# CENTER for SCIENCE in PUBLIC PARTICIPATION

October 11, 2024

**Re: Review of the US Forest Service Response to Comments from David Chambers (submitted December 29, 2022), originally submitted on the Stibnite Gold Project Supplemental Draft Environmental Impact Statement (2022)**

**From: David Chambers**

Figure 3-14. Design Cross Section through TSF Embankment and TSF Buttress

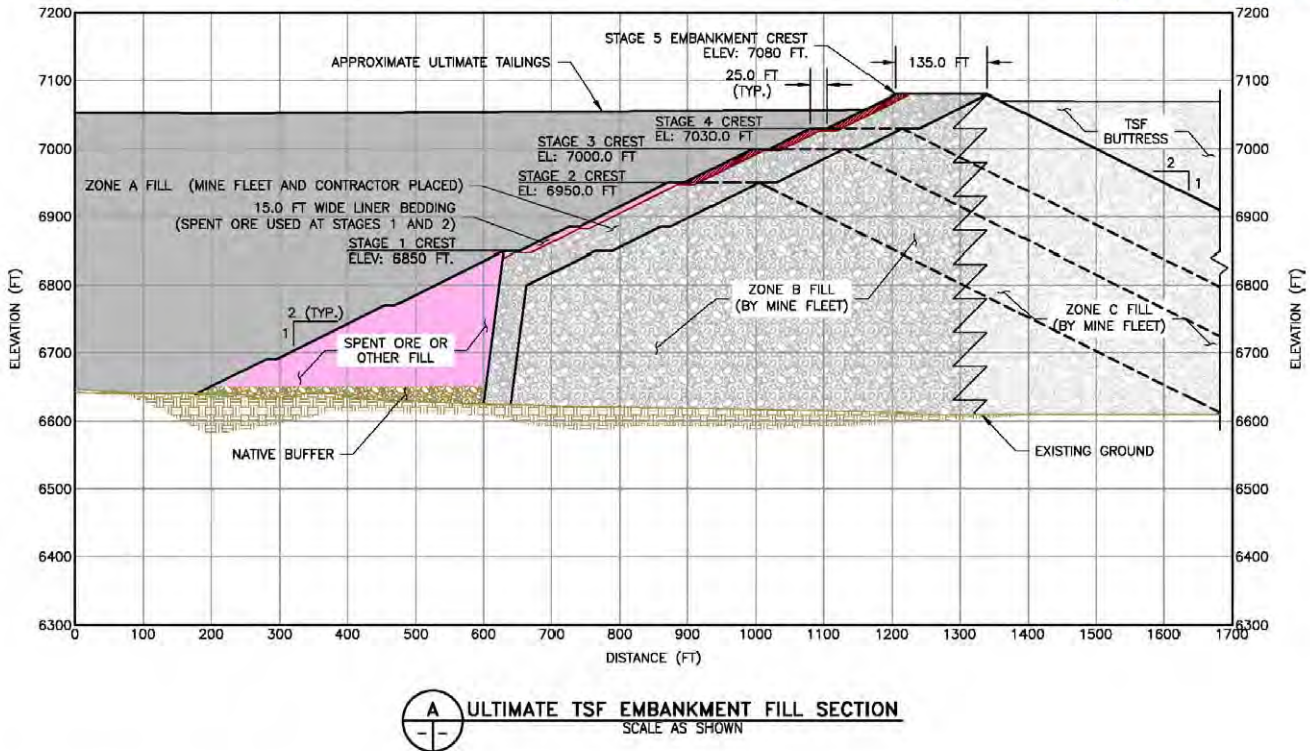
It is noted on Figures 2.4-10 and 2.4-11 that they were taken from the Stibnite Gold Project, Revised Proposed Action ModPRO2, Perpetua Resources Idaho, Inc. October 2021. In the same ModPRO2 document there is an additional figure (ModPRO2, Figure 3-14, below), which appears just before the two figures copied into the EIS from ModPRO2 (Figures 3-16 and 3-17), and now labeled Figures 2.4-10 and 2.4-11.

Figure 3-14 clearly shows centerline-type construction, not a downstream-type as stated in the FEIS. Utilizing cross sections from ModPRO2 in the EIS merely confounds the confusion, which is what I pointed out in my comments on the SDEIS. The dam cross sections in ModPRO2 and the D/FEIS were developed by Perpetua. The dam cross sections are not taken from a technical consultant's report, so it is not clear what, if any, actual engineering was used to develop these figures. Perpetua does not have the internal technical ability to design the tailings dam, or to certify its safety. That expertise comes from outside technical consultants, and there is no reference to a report from outside consultants.

While it is now clearly stated in the FEIS that the dam construction will be downstream-type, there is no technical information to confirm those statements. The existence of competent technical analysis is important because this analysis is needed to determine how the factors of safety were determined, and how the earthquake stability analyses was conducted.

As pointed out in my DSEIS comments, there is still a significant gap in the technical background information available for the EIS. The response in the FEIS has not addressed that gap. There is a promise of downstream-type dam construction, but at this point it is unsubstantiated by the information available.

Updated information regarding the tailings storage facility was incorporated into SDEIS with the downstream construction of the TSF embankment depicted in Figures 2.4-10 and 2.4-11.

All planned raises of the TSF embankment would be by downstream methods. ... The buttress would be developed in horizontal lifts, abutting the engineered tailings embankment fill (Figures 2.4-10 and 2.4-11).
